#### **ADDENDUM #2**

# Utqiagvik Courthouse Upgrades Bid Package PROJECT #UTQ-C-25-0015

Date: August 6, 2025

# BARROW COURTHOUSE - CLERK COUNTER REMODEL & SERVER ROOM UPGRADES

A-101

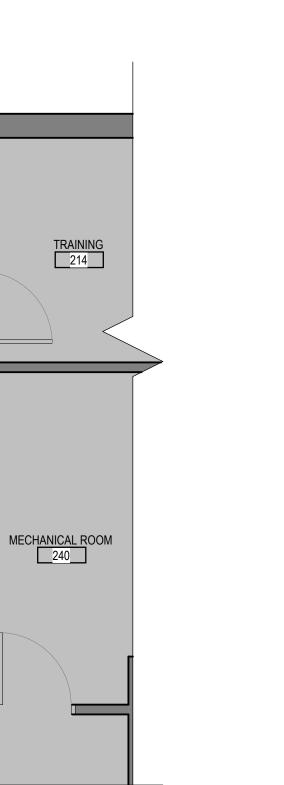
- Question: Sheet A-101 notes that there is no change to the sprinkler system. But pages A-102 & A-103
  not D5 and N5 indicate changes to the sprinkler system. Please clarify. Answer: Please see revised

sheet A-101 on the updated drawings attached.
